09-AFC-6

RE: **Blythe Solar Power Project, Docket No. 09-AFC-6** *Notification of Revision Memo – Blythe Solar Power Project Gen-Tie* Technical Areas: Project Description

BLYTHE SOLAR POWER PROJECT (09-AFC-6) NOTIFICATION OF REVISION MEMORANDUM

8	POPESSION, SZA	NFO			
	BLYTHE S U TILI TIES	RMATION		- CONSTRUCTION	
9	SOLAR POWER S CORRIDOR	0 Z		TION POWER	
	VER PROJECT	DOCUN		E R	
10	AECOM SUTE TOO SUTE TOO OAKLAND, CALIFORNIA 94612 PROJECT VG NO. SHEET-1	JMENT			
	тицицици т исн	гт		ω	>

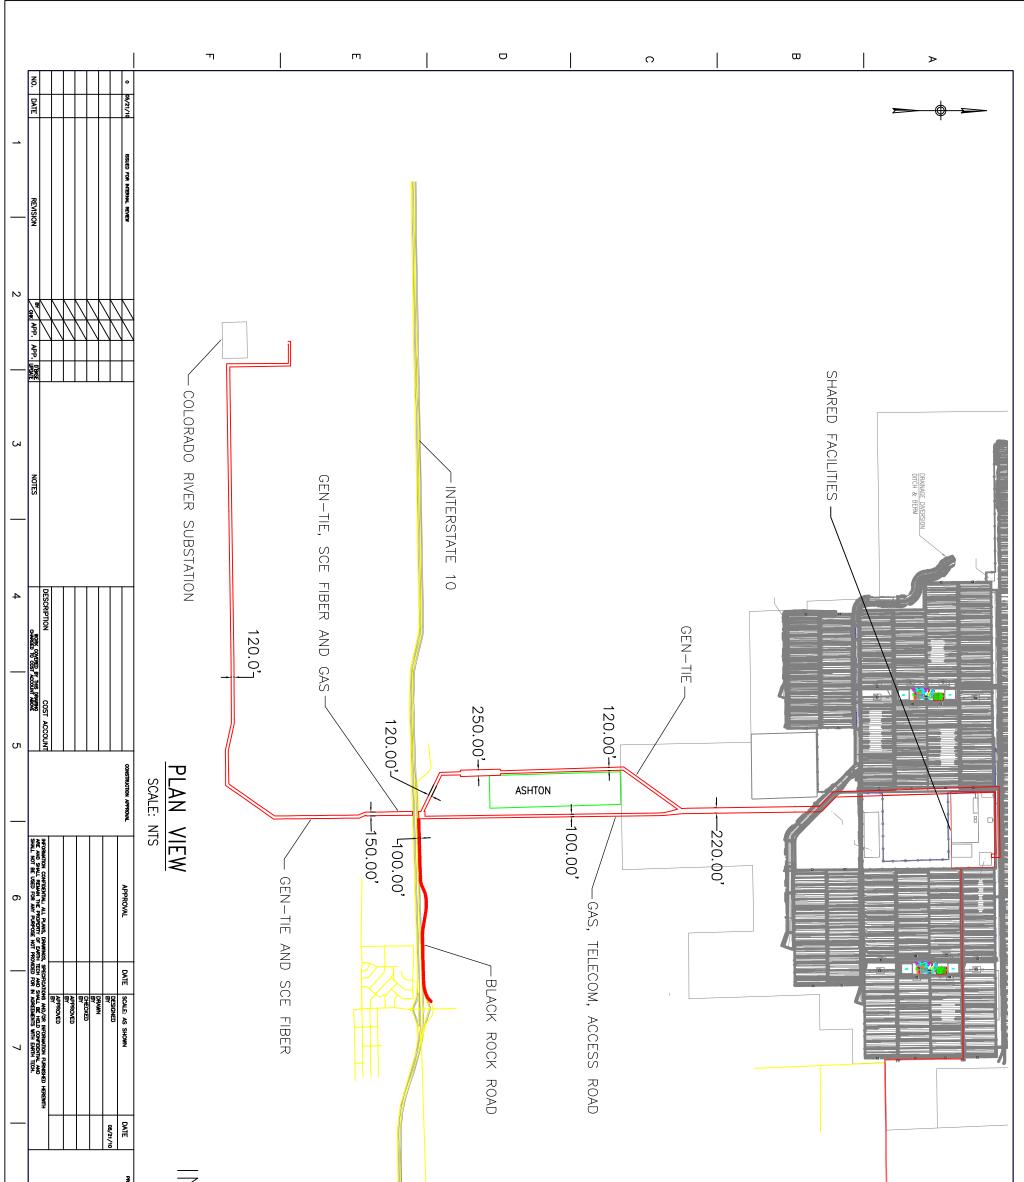
The Applicant has been engaged in extensive discussions with technical staff at the Riverside County Airport Land Use Commission (ALUC) with respect to the proximity of the proposed Blythe Solar Power Project (BSPP) and its associated linear facilities to the Blythe Municipal Airport. The airport is located approximately one mile east of the proposed linears. In discussions with the Project over the past month, the ALUC has expressed interest in a relocation of the proposed gen-tie line, which will extend due south out of the BSPP facility, cross I-10 and then proceed west to a point of interconnection with SCE's proposed Colorado River Substation. The ALUC would prefer that the portion of the current gen-tie route that is west and perpendicular to one of the main runway approaches be moved further west to preclude the potential for any effect on airport operations. Even though the FAA has approved the locations and heights of most of the transmission poles, the ALUC has made it clear that they would like to see an adjustment to this segment of the gen-tie route.

In response to ALUC's concern and in deference to our future neighbors, Solar Millennium has adjusted the gen-tie route further west. Specifically, Solar Millennium has relocated part of the gen-tie line approximately 0.35 miles west of the original alignment and 120-feet from the western edge of the Ashton private property. The total length of this re-route is approximately 2.3 miles thereby adding an additional 1600-foot to the original linear circuit length. The re-route has introduced four additional angles in the line with the largest angle being 63.14 degrees.

The re-located routing causes the gen-tie to pass through Zone D (90-ft height requirement) and Zone C (70-ft height requirement). The poles in these zones will meet these height requirements. To comply with relevant industry standards including G0-95, we expect four sets of single circuit H-frame structures to be used for the section of line passing through Zone C.

All other utilities including gas, telecommunications, and the site Access Road remain in the original alignment. Please see the attached figure for a representation of the revised alignment.
